ENGINEERING CHANGE NOTICE
DART AEROSPACE LTD

Date: 08.03.03	Job No.: 00056	ADR Yes/No: N	ADR Date:	ECN #:	1135
Product No.: D212-682		Created By: <i>MP</i>	Approved By: <i>MP</i>		
Product Name: LANDING GEAR KITS		Checked By: <i>MP</i>	General Manager Approval:

Add D412-682-001 Support Beam Kit and D412-682-111/-113/-115/-117 Landing Gear Kits

D212-682 Rev. D

Figure 32-1. Standard skid gear kit (Sheet 1 of 2)

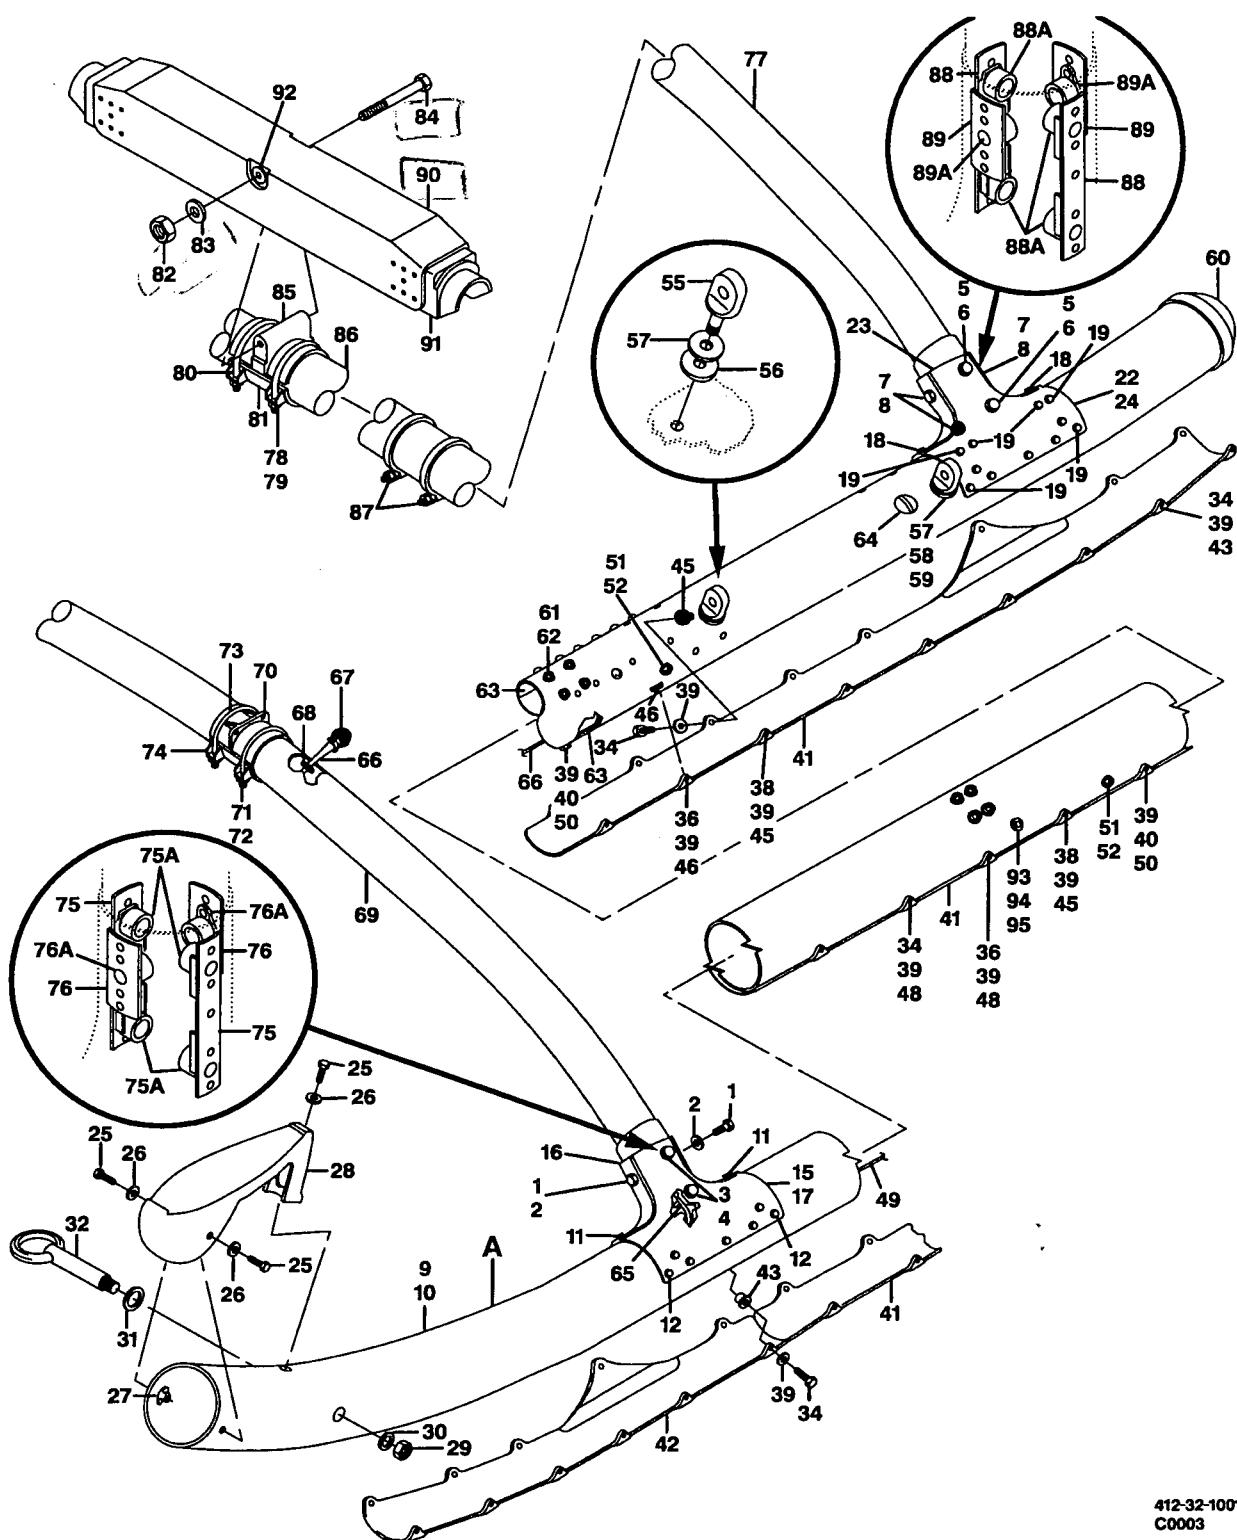
- a) AN320-8 is a castellated nut ... we should supply the cotter pin to complete this kit **DONE**
- b) We should reference AAI part numbers for rocker beam and bolt as options ... I am sure you can get this info from Frank Mah, if the part numbers exist **DONE**
- c) D412-682-111 should be D212-682-111 and D412-682-113 should be D212-682-113 ... catalogue is wrong. These kits don't get installed on 412. **DONE**

- (1) AN320-8 nut
- (1) NAS1149F0832P washer
- (1) 412-050-008-101 bolt
- (1) 412-050-003-109 support beam assy
